Campaign No. 2011100006, November 2011

SUBJECT: **Model 906, Model Year 2011**  
**Check Rear Springs, Replace if Necessary**

Figure 1

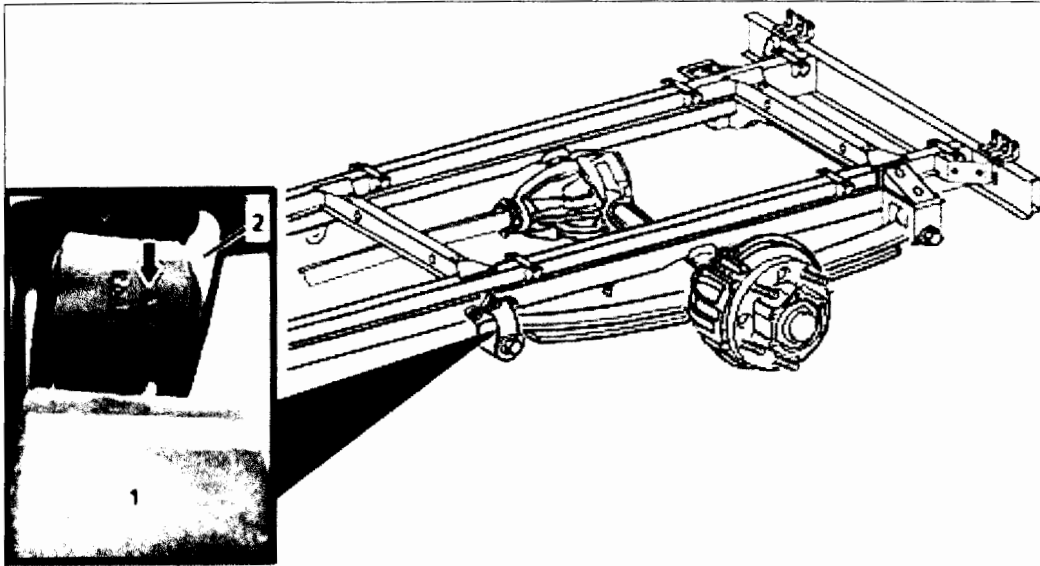
1. Check if batch number (arrow, Figure 1) is stamped on top of the front mounting eye (1, Figure 1) of rear axle spring using a mirror (2) then repeat inspection on opposite side:
  - If batch number stamped on **either the left or right** spring is **NOT**: SIAAA7 (on none of the springs), Procedure is complete.
  - If batch number stamped on **either the left or right** spring is: SIAAA7 (on one of the springs) proceed to step 2.
2. Replace **both** rear springs; refer to WIS; AR32.20-D-0230H.
